SETHI HOUSE, PESHAWAR

SITE INSTRUCTIONS

CONSERVATION RECORD DOCUMENT
Site Instructions Sheet

Repair of School Side Wall

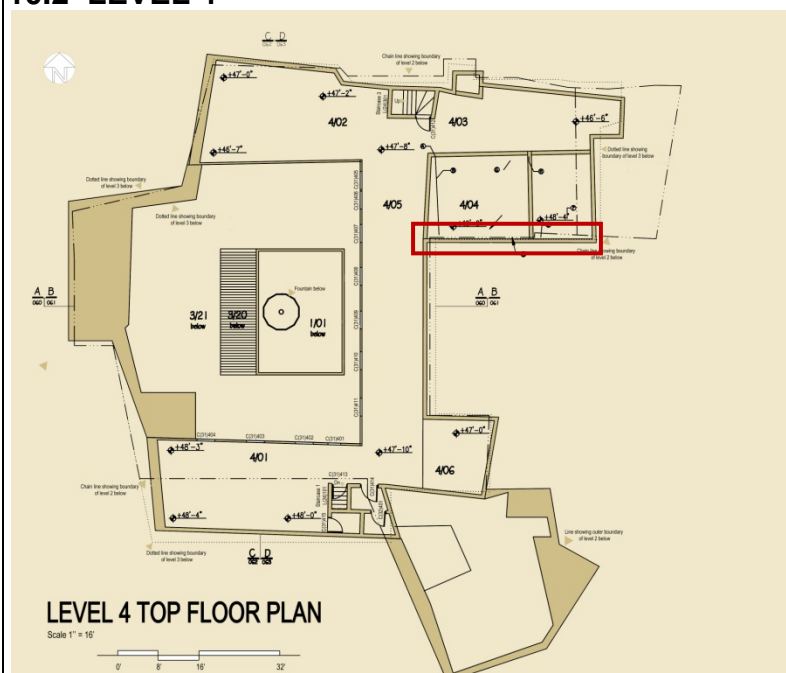
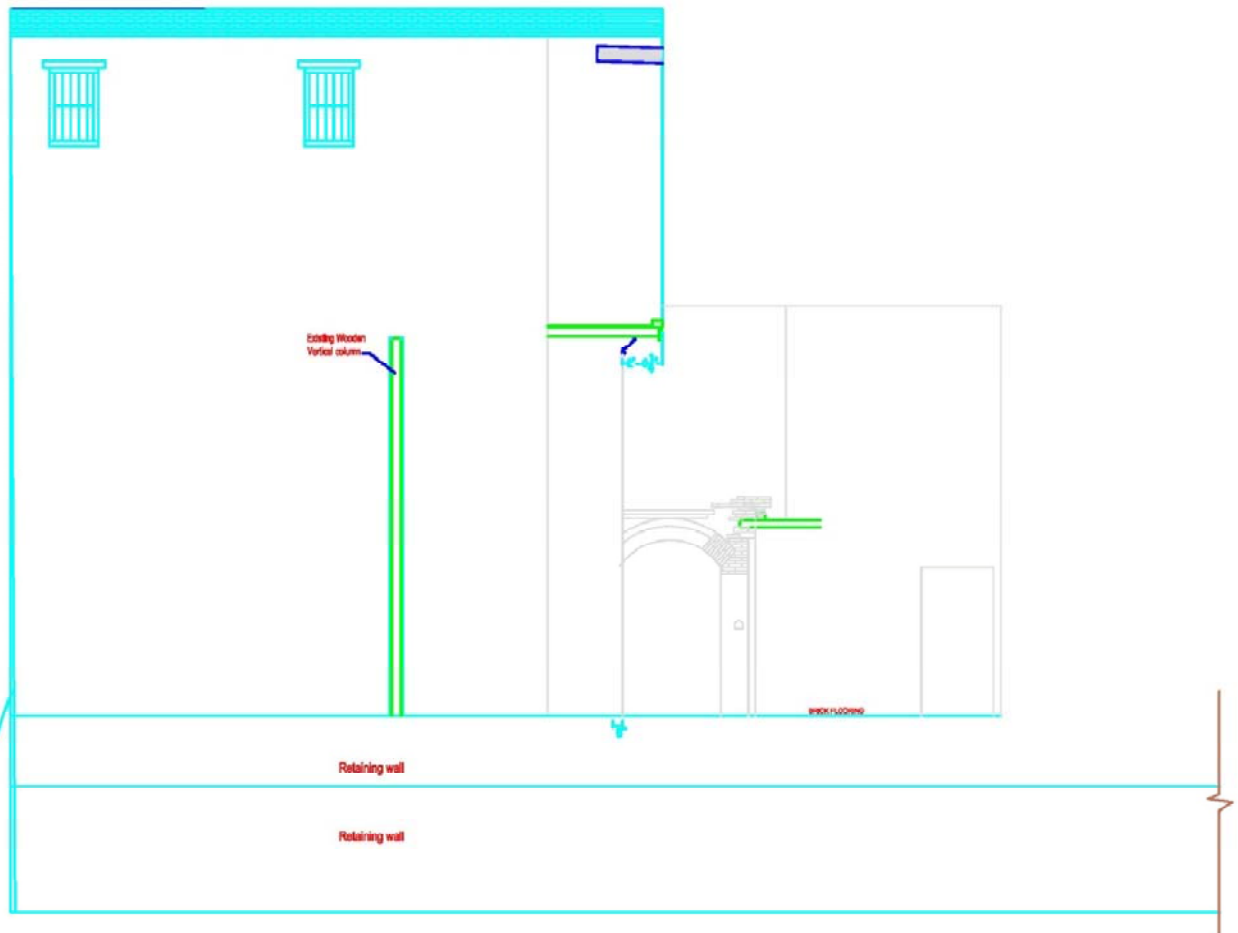
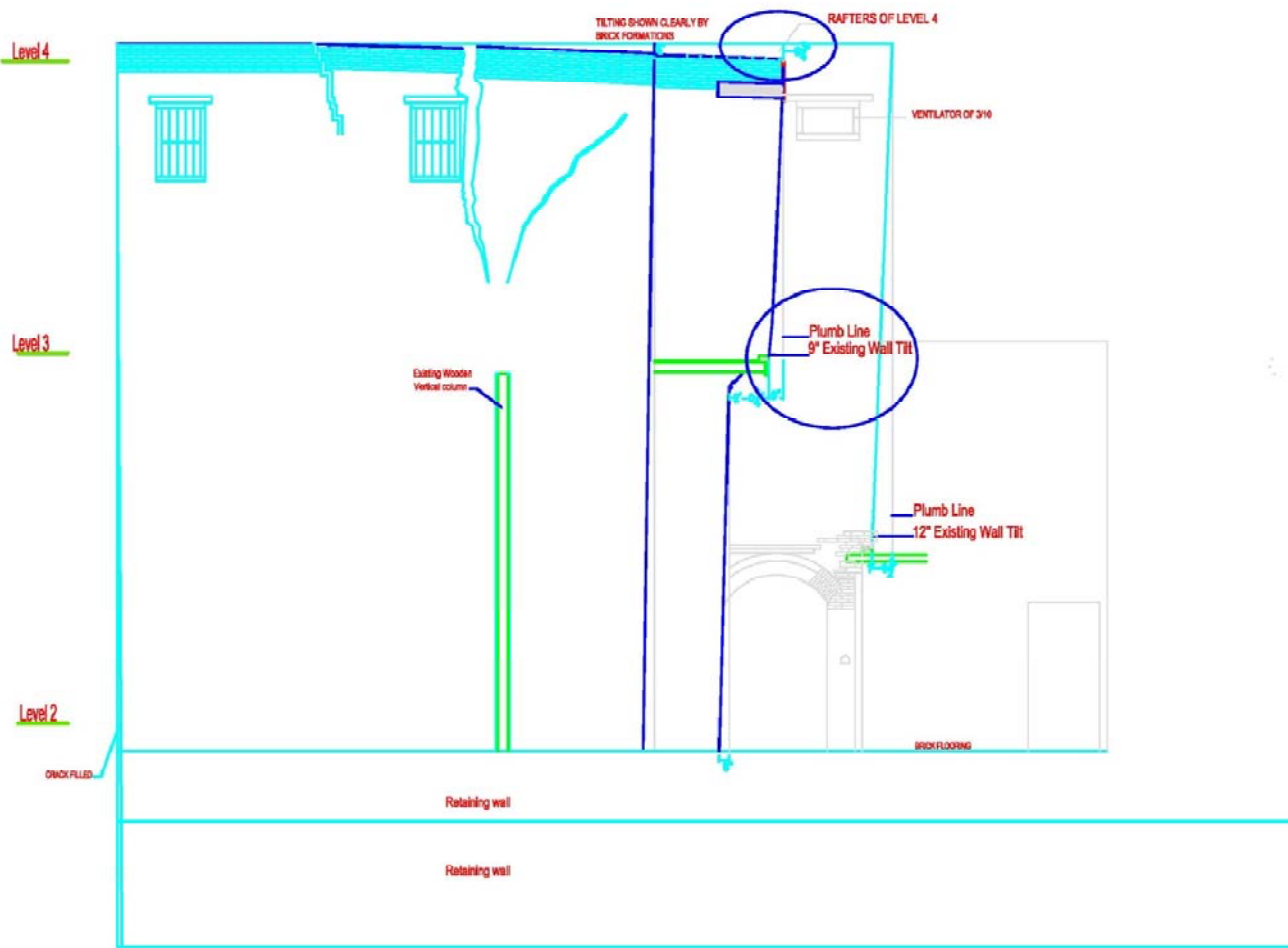
1. Mid historic portion interspaced with cracks. Investigations confirm tilt of wall and emphasis the danger and seriousness of crack along wall that is attached to school. Wall is 32" in width which extends to 34" as it approaches the south east corner
2. Crack to be filled in 2' wide
3. The wall in question is 20" in height, however in view of the examination, it has been found that the deformity is only one brick wide. It has been decided that the only portion where the masonry has been extremely damages must be taken down.
4. The crack should be filled with gypsum-lime water mix
5. The thickness of the fillings must be recorded
6. The actual filling (3"thick and 2" width) must reach the brick work.
7. Additional bricks may be laid to replace the ones removed, but keeping in with the course and bonding as the original. The use of lime Mortar is advised.

NOTE: The bricks that have been taken down must be cleaned and reused.

Title of Works:
 Repair of fractured wooden beam

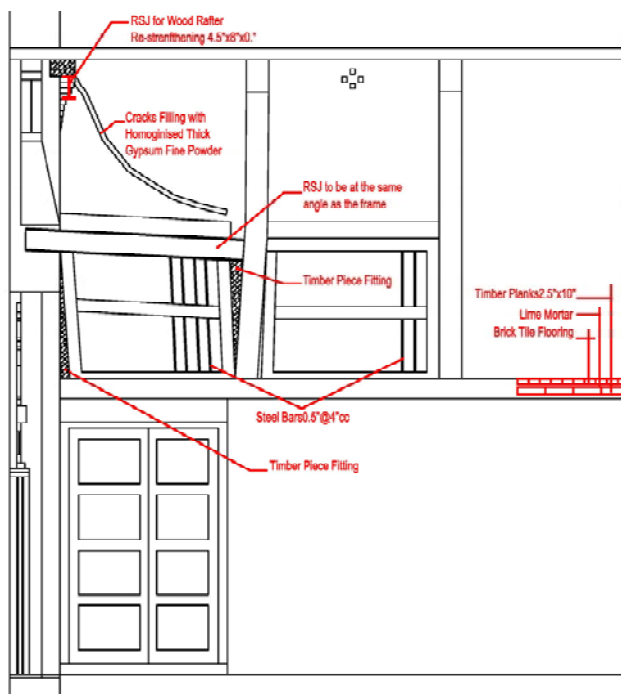
1. Preamble: Fracture on beam has caused a depression in the roof causing a huge hole. As a result, rainwater has been pouring in with no drainage. This has caused extreme damage to the floor as well as the unique tarseem bandi. Since extreme caution was required in order that the structure may not be altered, the roof couldn't be dismantled and work needed to be undertaken with extreme caution.

2. Removal: Existing brick flooring, earth and other filters to be removed hence exposing the location of the fractured wooden ceiling. Checking of other timber element is also required.

3. Scaffolding to be erected to support fragile and dangerous portion. Ceiling supported with special provision of sponge to avoid harming tarseem bandi.

4. RSJ to be placed on top of the fractured beam. Hole to be drilled into wooden beam and bolted to the RSJ. The bolts should be gradually tightened to lift the wooden beam and hence change its position to maintain the required level. Excise extra caution

5. Plates to be placed on the top and bottom and bolted into place
6. Plates to be secured to support fractured portion.

1. Damaged beam to be replaced with new deodar anti-termite treated beam

Title of Works:
 Dismantling later period construction on east façade

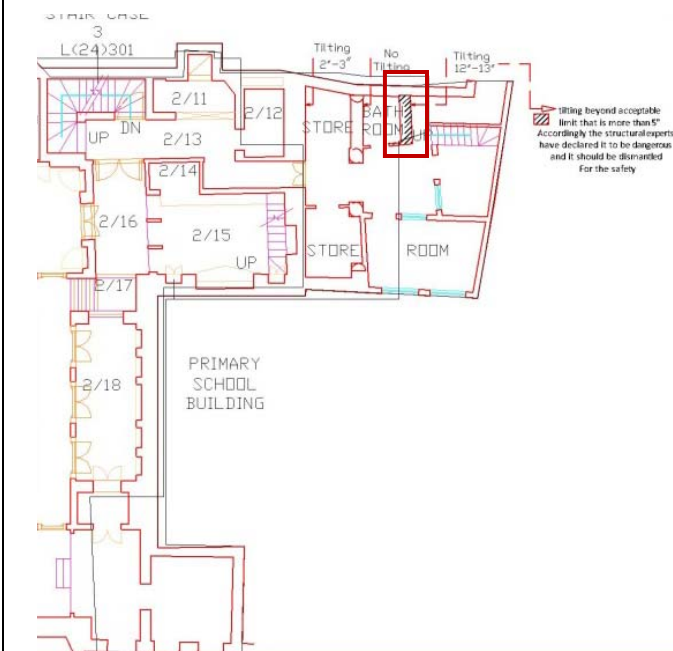
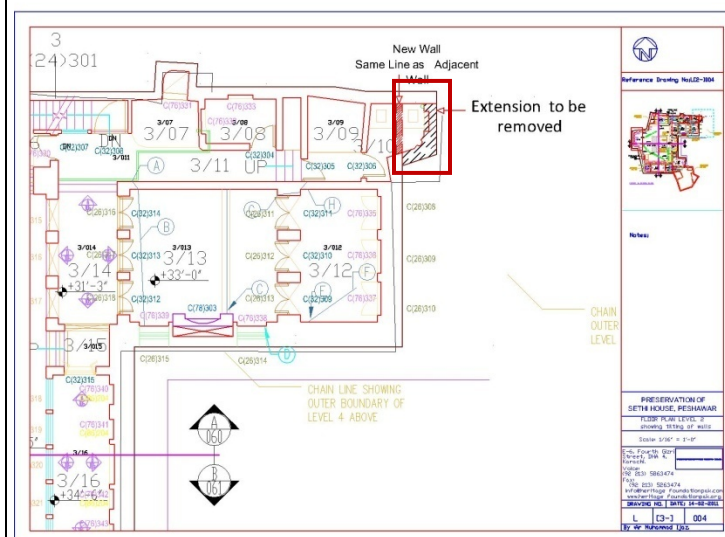
- On checking of the east wall was found to be tilting beyond acceptable limit that is more than 5 inch in fact the tilting is 12inch – 13inch.

Accordingly the structural experts have declared it to be dangerous and it should be dismantled
 For the sake of safety

- It is clear that it is a later period construction for the following reasons
 - There is no bond between the saying room and the other part.
 - It is blocking the arch of the eastern façade. Shown in attached drawings.
 - It is than that the upper portion of the wall was demolished to make place for the new bathroom.

For the above reasons and for the sake of public safety as well as a stabilization of original structure It has been decided to dismantle the wall of the bathroom as shown in attached drawing.
